## **KHNP Response to Request for Additional Information No. 2-7371**

Please provide the following documents referenced in the topical report (TR) APR1400-Z-M-TR-12003-P, Rev. 0:

Figure RAI-10 A schematic diagram of the SIT-FD

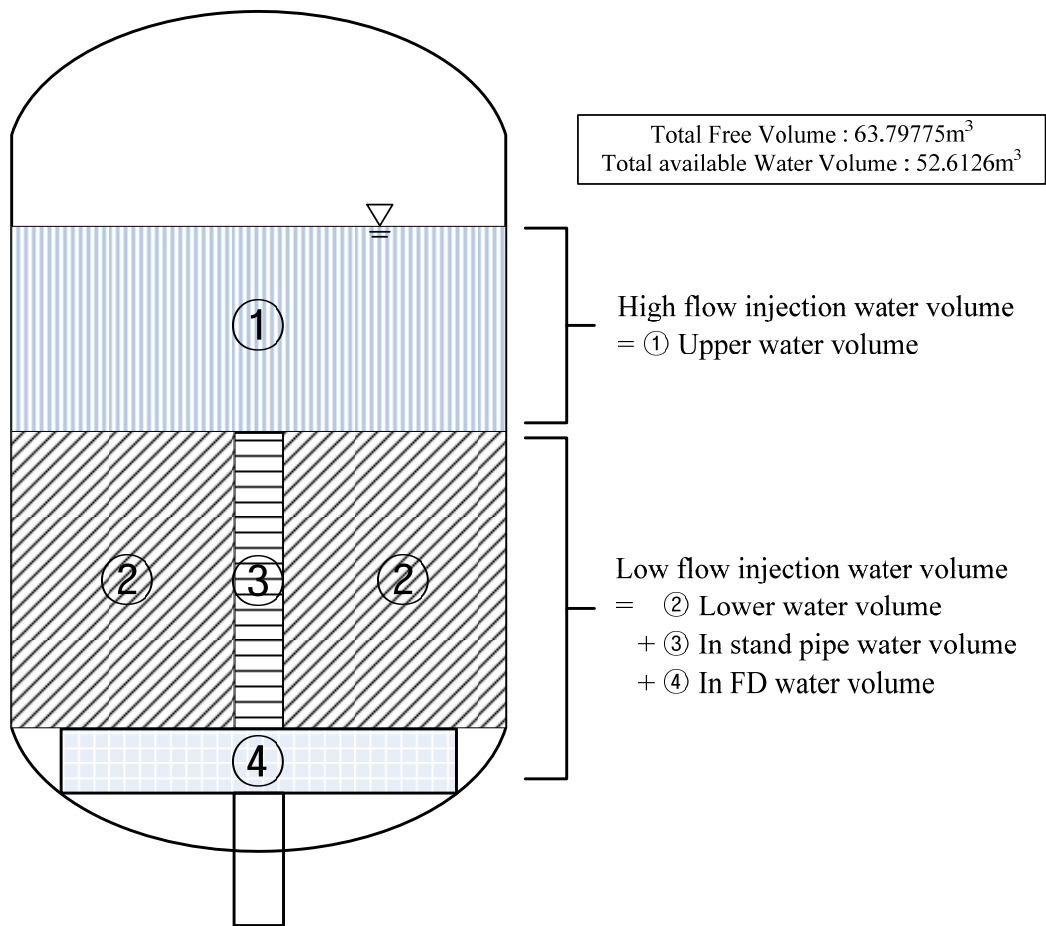
Figure 4.3-1 and 4.3-2 show the flow rate turning point (around 30 seconds) when the SIT water level (after subtracting [  $t_s$  ]) is close to the stand pipe level.

- In all tests do the flow rate turning points (switching from large to small flow rate) occur when the SIT water level decreases to the stand pipe elevation?
- What are the variations of the SIT water level from the stand pipe elevation observed in these test?
- In the LOCA safety analyses, what is the criterion used to determine the flow rate turning or switchover from the large-flow injection phase to the small-flow injection phases so that the corresponding K-factors can be used?
- How is the variation or uncertainty of the SIT water level for flow rate switching accounted for in the safety analyses?

*a&b) Table RAI-10 shows the Flow Rate Turning Time (Column [A]) and the difference between SIT water level and top elevation of stand pipe height at the flow rate turning time (Column [E]). The flow rate turning time corresponds to the time when the stand pipe water level starts to decrease abruptly.*

*Column [B] is the SIT water level at the flow rate turning time. Column [C] is the length (or height) of stand pipe.  $\Delta H$  in Column [D] is the elevation difference from the reference elevation of SIT water level (SIT bottom) to the elevation at the bottom of the stand pipe.  $\Delta H$  is [  $t_s$  ].*

*The SIT water level at the flow rate turning time is, on average, [  $t_s$  ] higher than the top of the stand pipe. The standard deviation for the difference (Column [E]) is [  $t_s$  ].*

*The results of SIT-FD model assessment against VAPER tests show that the SIT-FD model described above reasonably predicts flow rate turning time from large flow injection phase to small flow injection phase. The details of SIT-FD model assessments are described in Appendix H of TR CAREM.*

*Table RAI-18 A draft ITAAC for the FD design*

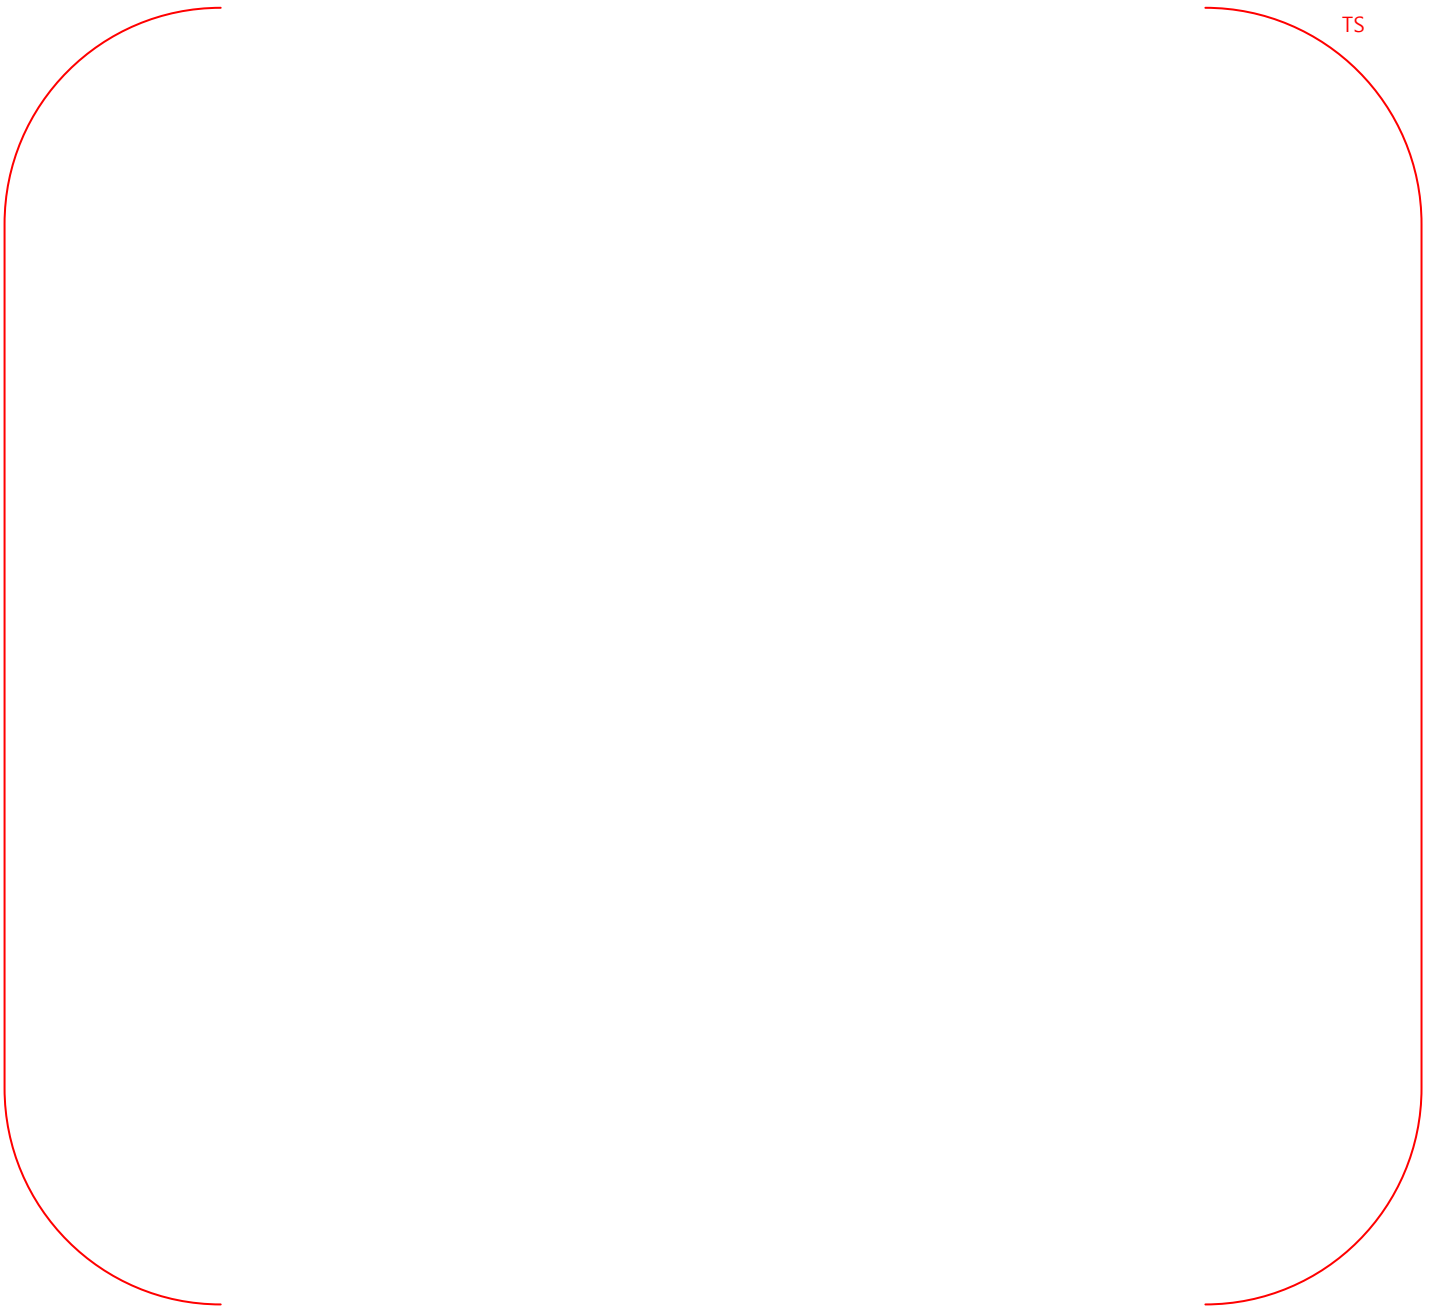
Since the FD verification test results are applicable to the specific FD design configuration, what process will be used to assure that no changes are made to the APR1400 SIT/FD design configuration?

*SIT-FD (FD) design is followed by configuration control process as follows. KAERI produced the Full Scale Test results as stated in the topical report and performed an internal QA process during design confirmation. The final FD design in U.S. will be provided to KHNP from KAERI, and then KHNP will provides the final FD design to the manufacturer; Doosan Heavy Industry (DHI), after KHNP's internal QA process. DHI will perform its internal QA process at manufacture stage. Configuration Control for the FD design will be properly maintained since each organization performs own internal QA process. KHNP is responsible for all the processes. The main parameters of the SIT-FD such as SIT water volume, K-factor for large and small flow period will be described in ITAAC. Figure RAI-18 is shows a draft ITAAC for the FD design.*
